Type <b>Coffee Vending Machine</b>	Model <b>KORO PRIME – KORINTO PRIME</b>	N° T.I. <b>07 - 2022</b>					
Serial Number <b>22420254</b>	Subject <b>MODIFICATION OF CAPACITIVE KEYPAD ASSEMBLY</b>	ISSUED FOR (X)	<table border="1"> <tr> <td>Action</td> <td></td> </tr> <tr> <td>Information</td> <td><b>X</b></td> </tr> </table>	Action		Information	<b>X</b>
Action							
Information	<b>X</b>

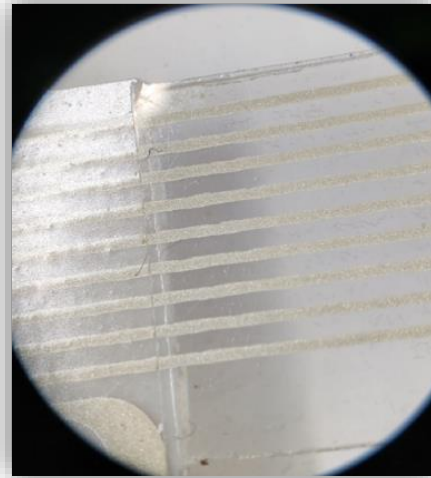
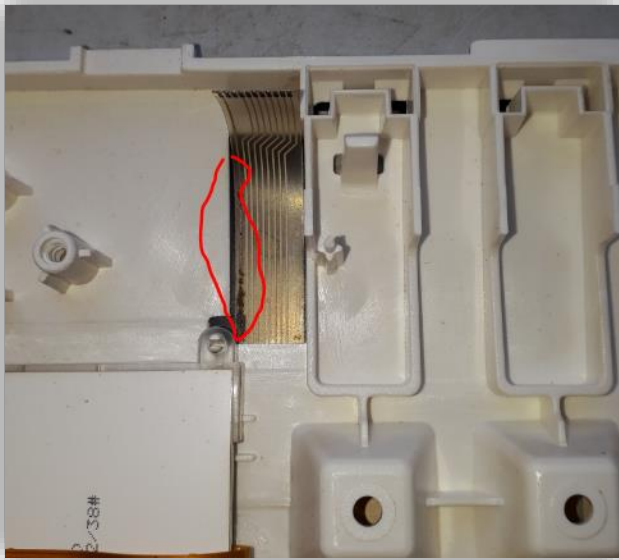
the production process of the capacitive board **flat cable** has been improved.

We introduced a *protective polyethylene layer* on the TOP surface of the **flat cable**. Previously it was only protected by conformal coating.

The spare part code of *Capacitive Keypad assembly* is not changed: **260355**
